# Access Compliance Report

## Public Rights-of-Way

Intersection ID: 10006563	Main Street: SHADE_VALLEY_RD	Cross Street: OAKHURST_COMMONS_DR	Location: SW
ADA ID: DE2AB3577DB5	Ramp Type: Perp	Initial Pass/Fail: Fail	Overall Compliance: No
Severity Score: 25			
Codes/Mitigation Info/Possible Solution		Field Measurements/Component Compliance

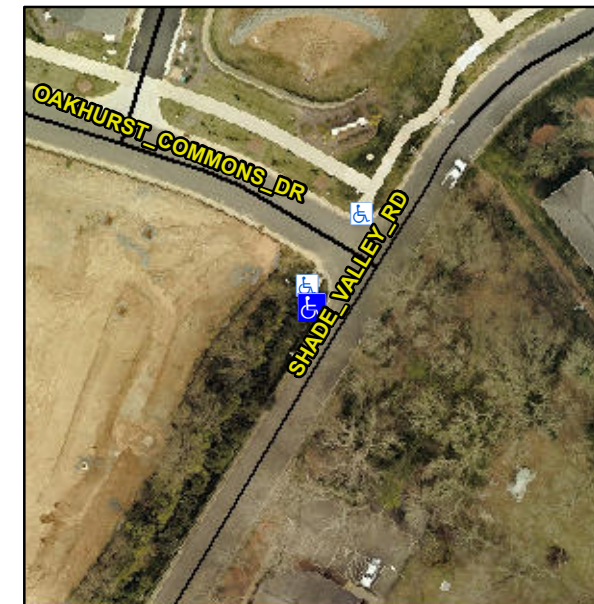
**R304.2.2, R304.5.3**

Compliance	Description	Data	Compliance	Description	Data
N/A	Ramp Length (in)	71.0	No	Ramp Slope (%)	10.0
Yes	Ramp Width (in)	90.0	No	Ramp XSlope (%)	5.7
N/A	Flare Type LT	N/A	N/A	Flare Type RT	N/A
N/A	Flare Slope LT (%)	N/A	N/A	Flare Slope RT (%)	N/A
N/A	Flare Traversable LT?	N/A	N/A	Flare Traversable RT?	N/A
N/A	Landing Length (in)	N/A	N/A	DWS Provided?	N/A
N/A	Landing Width (in)	N/A	N/A	DWS Contrast?	N/A
N/A	Landing Slope (%)	N/A	N/A	DWS Length (in)	N/A
N/A	Landing X Slope (%)	N/A	N/A	DWS Full Width?	N/A
N/A	Landing Curb? (Y/N)	N/A	N/A	DWS Offset (in)	N/A
N/A	Shared Landing?	N/A			
N/A	Gutter Ponding?	N/A	N/A	Gutter Slope (%)	N/A
N/A	Gutter Lip Ht (in)	N/A	N/A	Gutter X Slope (%)	N/A
N/A	Painted X Walk1?	No	N/A	Painted X Walk2?	N/A
	X Walk 1 Direction	To SE		X Walk 2 Direction	N/A
N/A	X Walk 1 Width (in)	N/A	N/A	X Walk 2 Width (in)	N/A
	X Walk 1 Slope (%)	2.8		X Walk 2 Slope (%)	N/A
	X Walk 1 X Slope (%)	334		X Walk 2 X Slope (%)	N/A

**Remove & Replace Entire Ramp.**
